DEPARTMENT OF ECOLOGY

Re: Water Quality Certification for U.S. Army Corps of Engineers Public Notice 1996-4-02325 (Amended-1); Construction of a Third Runway and related projects at the Seattle-Tacoma International Airport (STIA) in the Miller, Walker, and Des Moines Creek watersheds and in wetlands at the Seattle-Tacoma International Airport, located within the vicinity of the city of SeaTac, King County, Washington; and in wetlands at the mitigation site in Auburn, King County, Washington.

ORDER #1996-4-02325 (Amended -1)

Attachment B: NRMP Plan Set Revisions

Borrow Area 3 Wetland and Swale Buffer

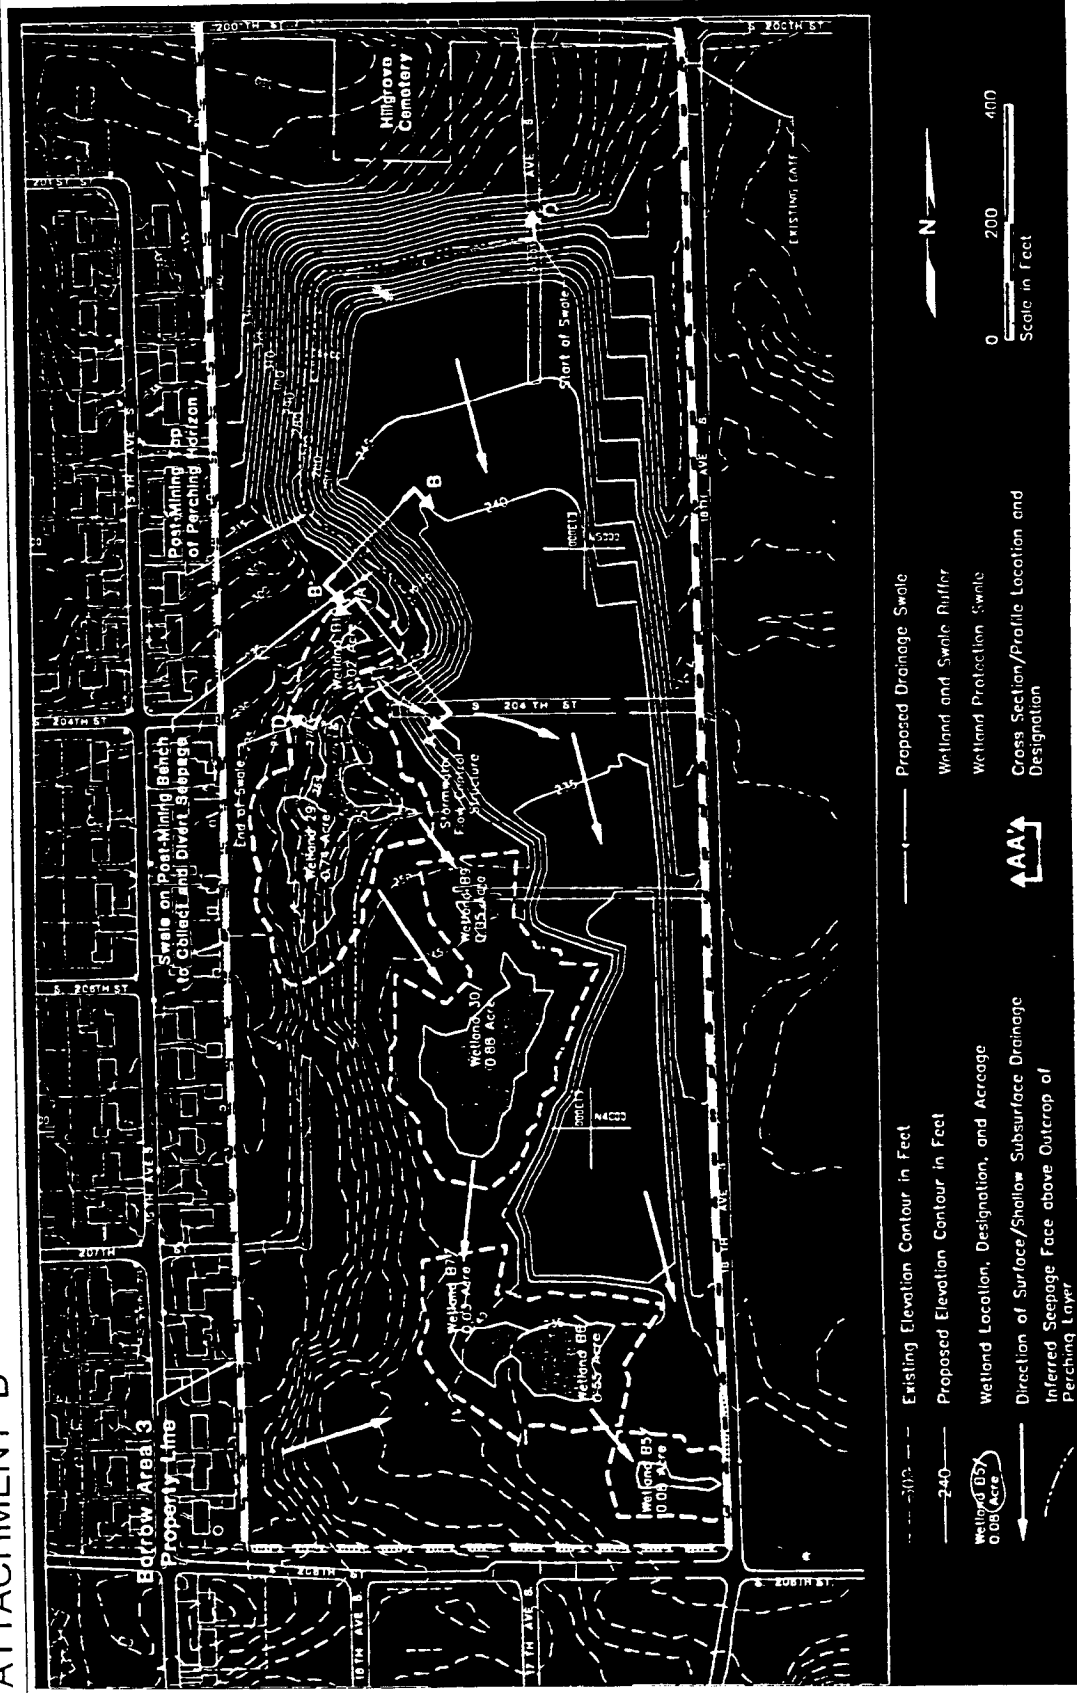
- a) The site plan from Hart Crowser titled Post Reclamation Topographic detail Borrow Area 3 Wetland Protection Swale HNTB revision (June 15, 2001 Draft) shows a flow dispersal trench overlapping with a small portion of Wetland 29. The flow dispersal trench shall not be constructed so that it is in the wetland.

- f) **Increased Buffer Area:** In order to protect the hydrologic functions, and hydrology supporting Wetlands 29, 30, B5, B6, B7, and B9, all areas up slope of the wetlands within the property shall be included in the wetland buffer. Additionally, the Port shall ensure protection of hydrology to Wetlands 29, 30, B5, B6, B7, and B9 from future development. The wetland protection swale shall also be included in a restrictive covenant, with 25 foot buffers on either side of the swale. Those areas are depicted in **Attachment D (Revised)**, Borrow Area 3 Wetland Buffer. A restrictive covenant shall be drafted for this additional buffer area. The restrictive covenant shall be consistent with other restrictive covenants established for this project. The Port shall record the restrictive covenants with King County no later than sixty (60) days after the issuance by the U.S. Army Corps of Engineers of the Section 404 required for construction of the Master Plan Update projects. This condition applies only to property currently owned by the Port.
